Addendum #4

Date: 02/12/2024

Project: 2024 – Fishers Elementary School Addition & Renovations

PROJECT NO: 2021119 DATE: 02/12/2024 BY: Josh Cannaday

**COVER**

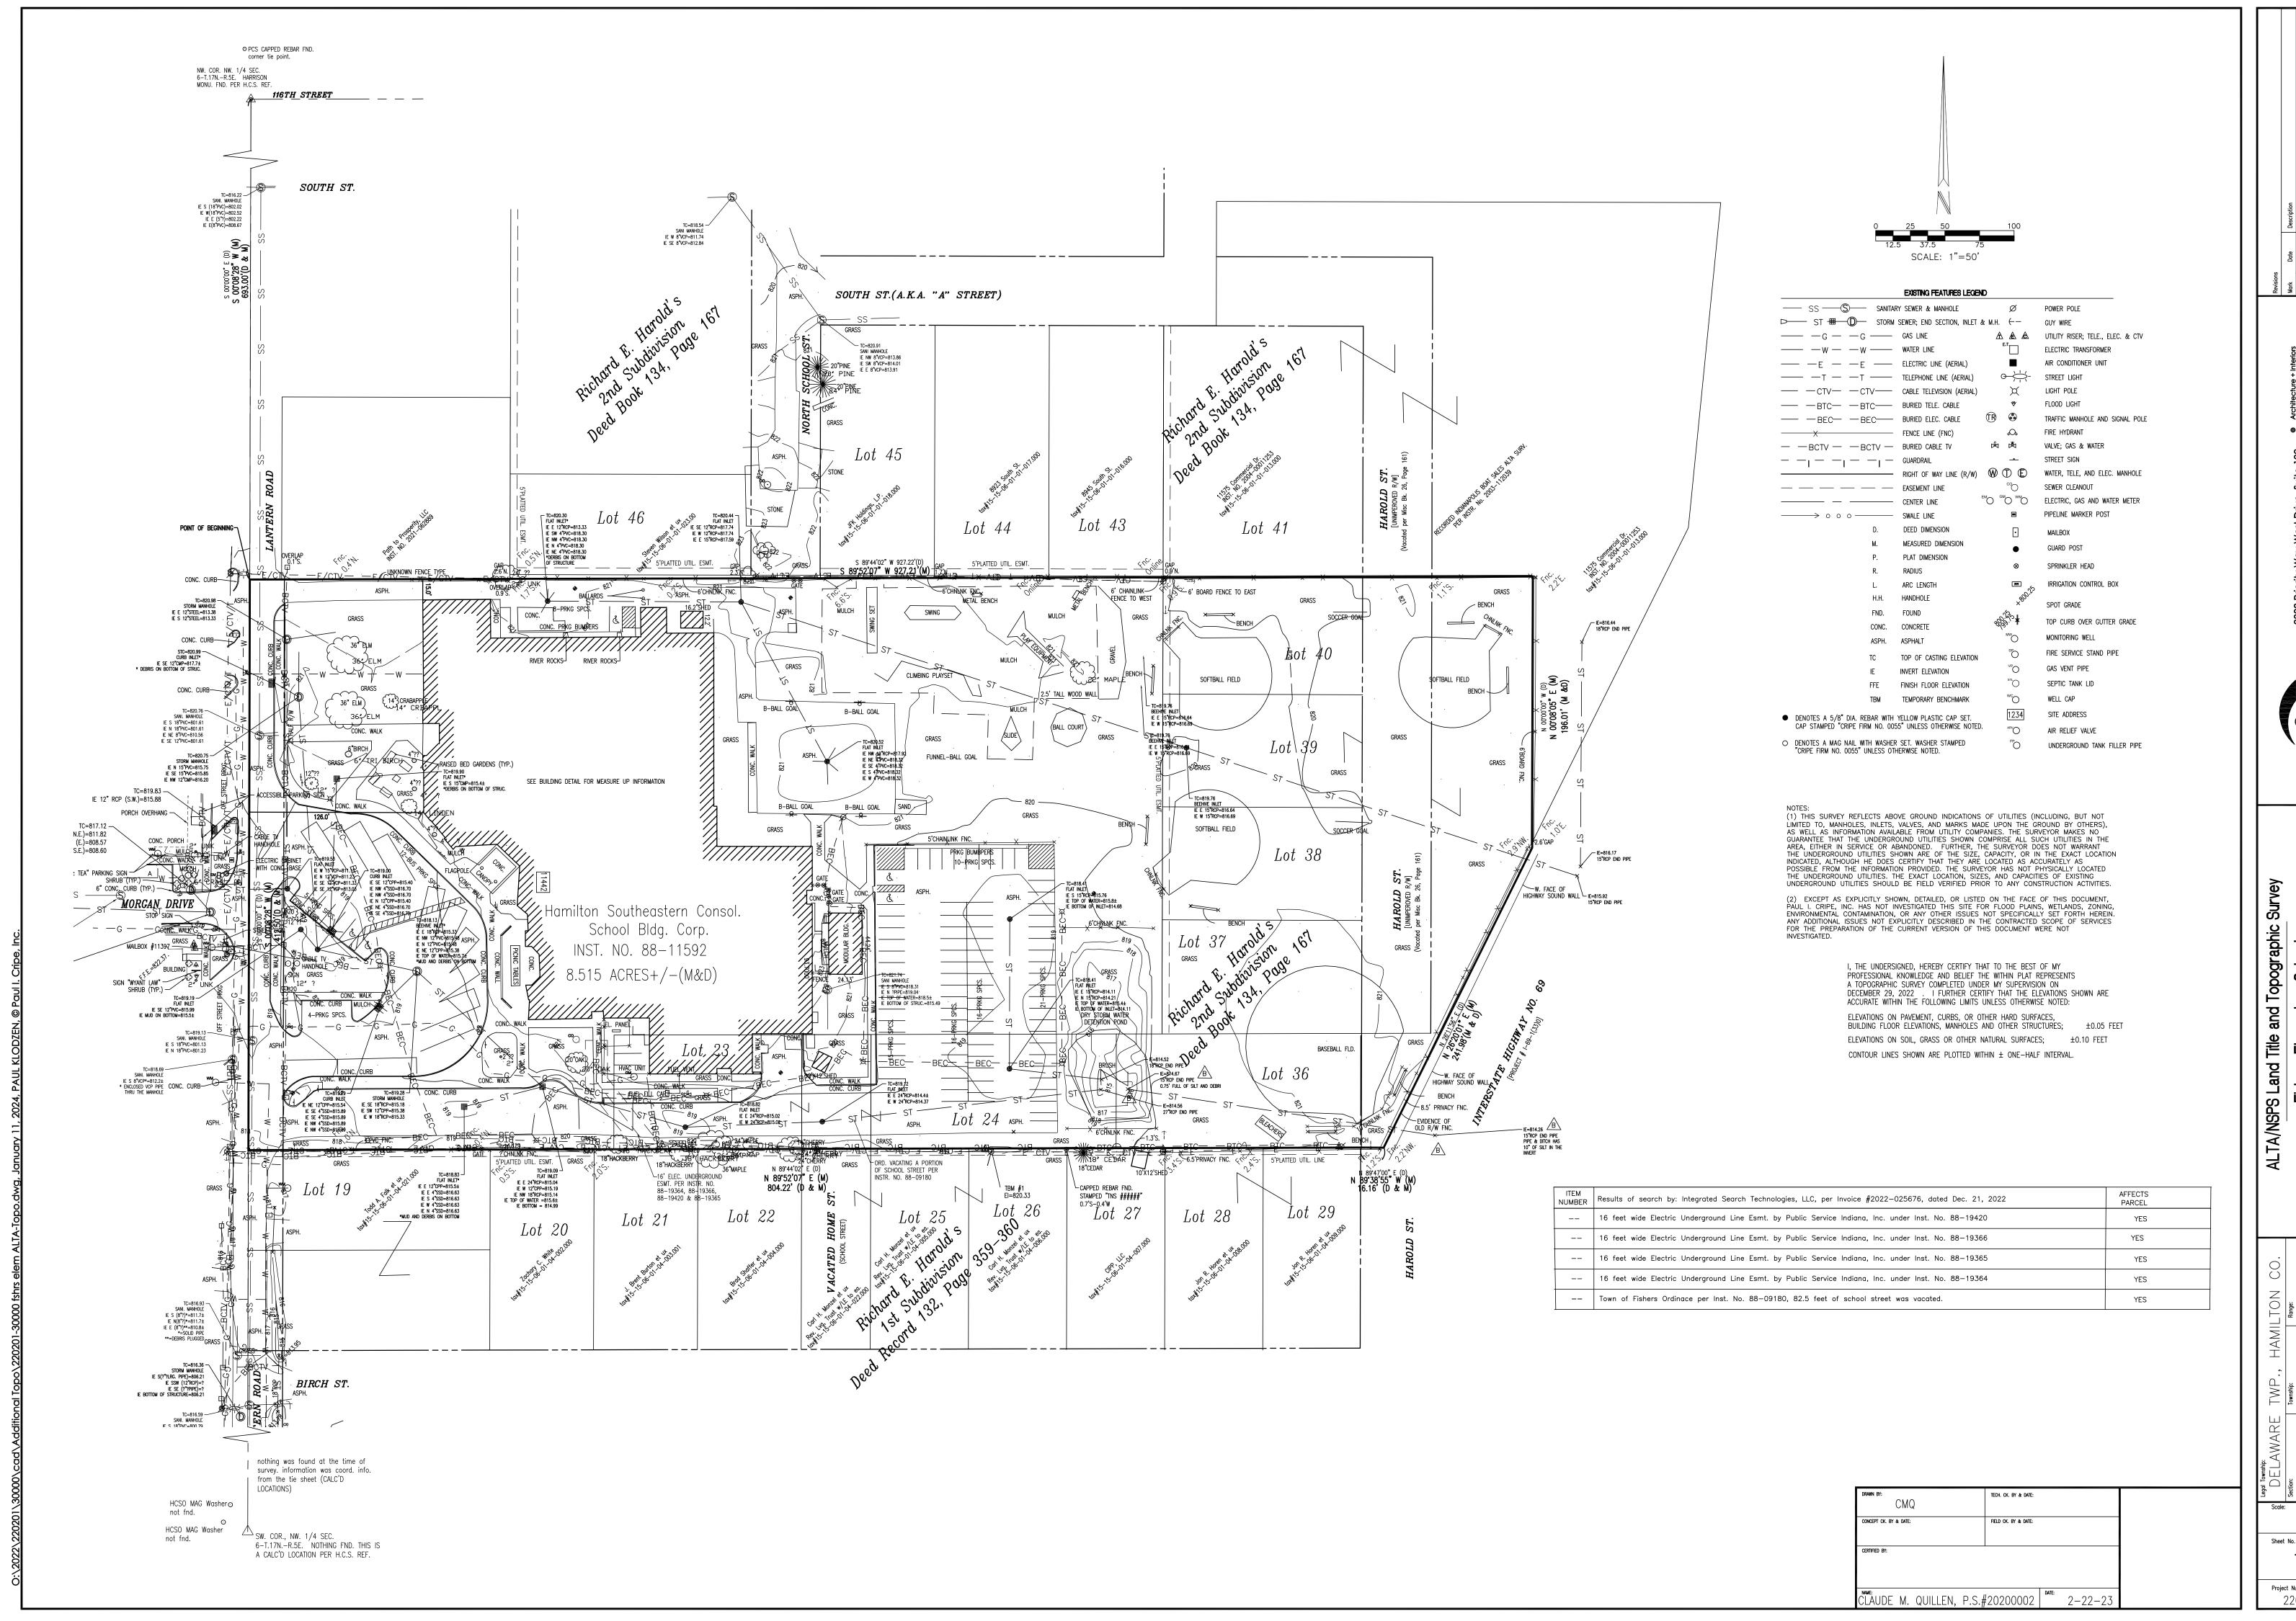
- 4.1 CS
  - A. Note removed about common area and perimeter paths per City request.
- 4.2 C101
  - A. Updates to keynote legend.
  - B. Made adjustments at main entry drive based on alignment and crosswalk comments received from City.

DRAWING NUMBER C201

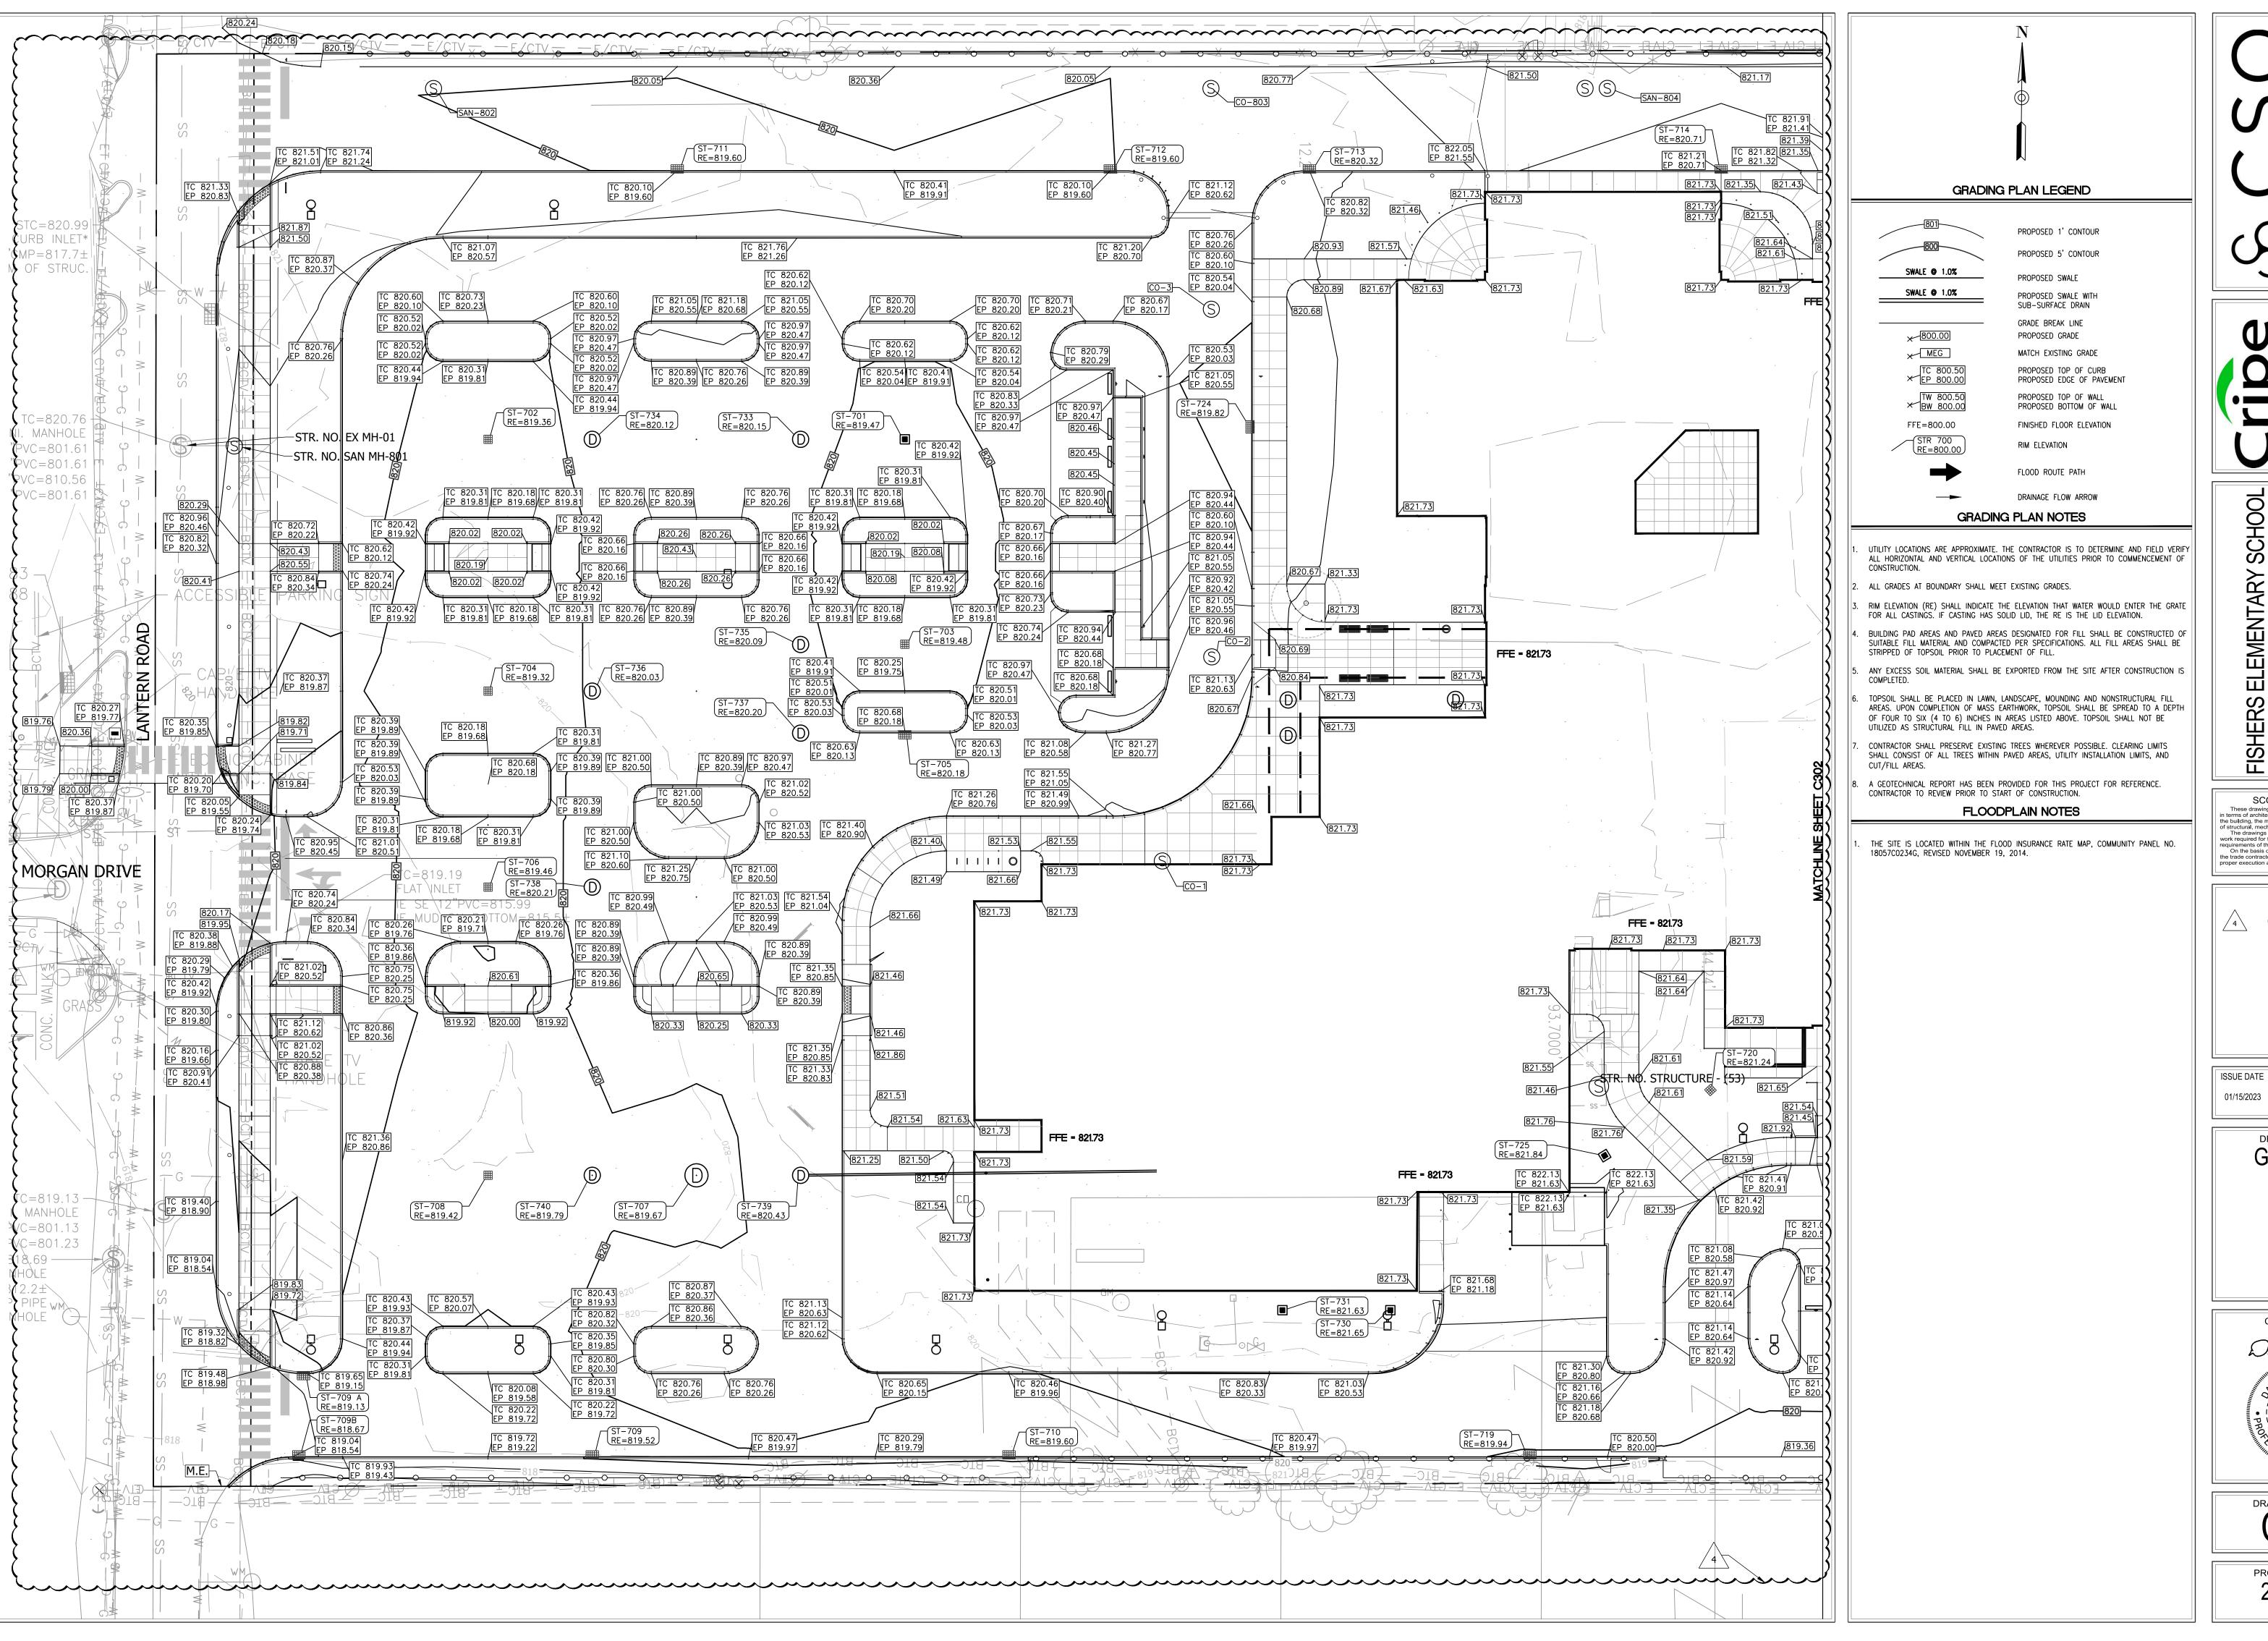
- A. Updates to keynote legend.
- B. Added street lights per City of Fishers and bore of conduit to electrical cabinet at Morgan along east side of Lantern see Electrical Plans
- C. Added crosswalk and ADA Ramps to Lantern Road north of Morgan Street. Removed south crosswalk and ADA Ramps
- D. Rework of curb ramp on southwest corner of Lantern & Morgan.
- E. Thermoplastic Crosswalk pavement markings required in R/W at all three driveways and crossing Lantern.
- F. Adjusted Main entry drive alignment per City request.
- G. Added information for Rectangular Rapid Flashing Beacon assembly at Lantern Road Cross Walk per City requirements.
- H. Added dimensions and transportation easement along Lantern Road R/W.

DRAWING NUMBER C301

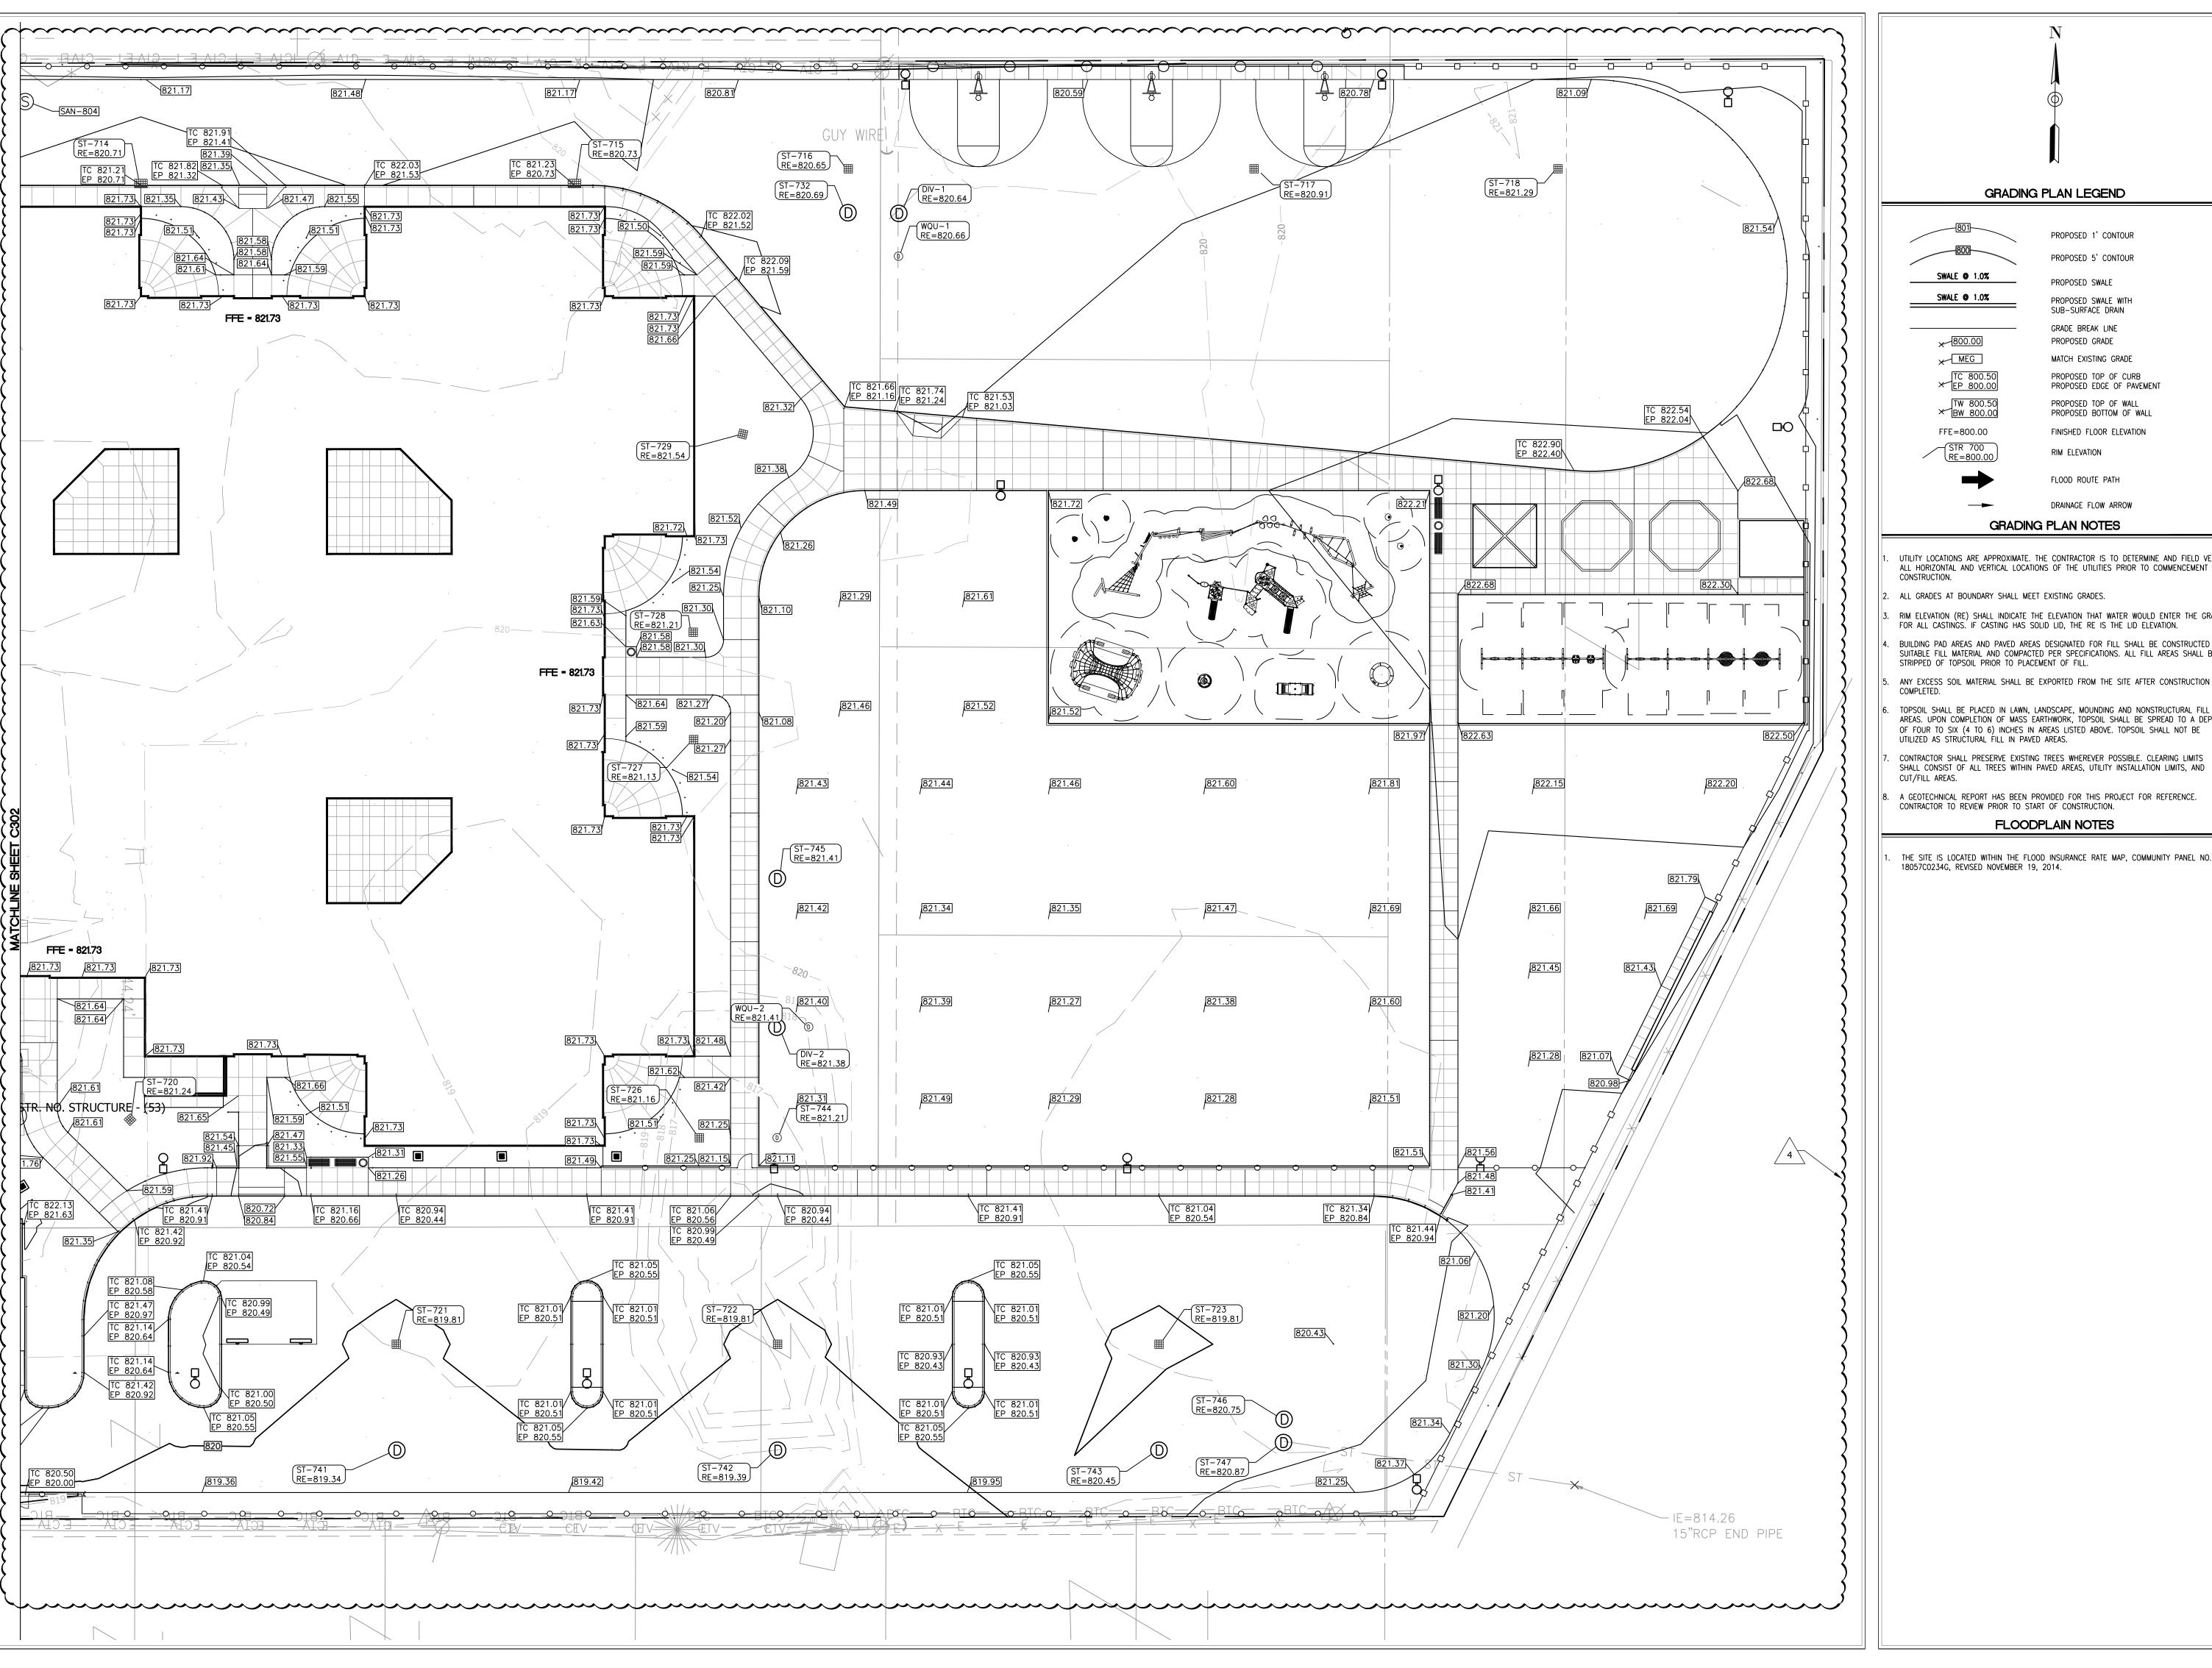
- A. Update to entrance and islands and grading.
- B. Added additional spot grades for more detail and clarification generally and in the truck dock area and new building south entrance.
- C. Re-graded north entry drive.
- D. Re-graded south entry drive.
- E. Added grades for slopes at entry drives along walking route.
- F. Revised grading at main entrance.
- G. Updated Floodplain map and notes.
